RELAYS (NONWIRE SPRING-TYPE), 197-TYPE SWITCHES, CROSSBAR SWITCHES, AND KS-13835 (AMA) READER REPLACING CONTACTS

1.001 This addendum supplements Section 069-310-802, Issue 7.

1.002 This addendum is issued to revise 4.01 and to add new Fig. 4.1.

Fig. 4.1—Dome-Shaped Contact Mating With a Bar Contact

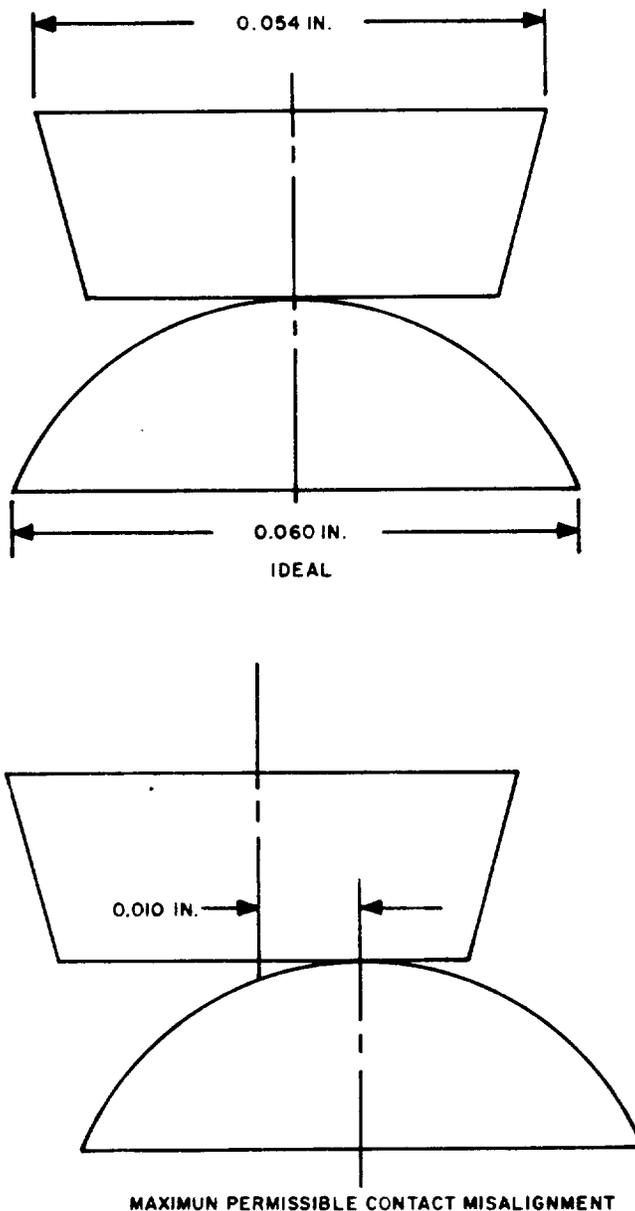
4.01 When replacing a point- or disc-type contact, its mating contact must also be replaced. Also, if there is a point-type contact on the opposite side of the spring from the contact to be replaced, the contact on the opposite side and its mate must also be replaced. On step-by-step relays with dome-shaped contacts and on relays equipped with springs having single bar contacts, do not replace the mating contact if it is not necessary. In this case, the dome must lie wholly within the length of the bar and the center line of the dome must be within 0.010 inch of the center line through the width of the bar as gauged by eye. (See Fig. 4.1.)

2.002 On Page 8, add Fig. 4.1—Dome-Shaped Contact Mating With a Bar Contact.
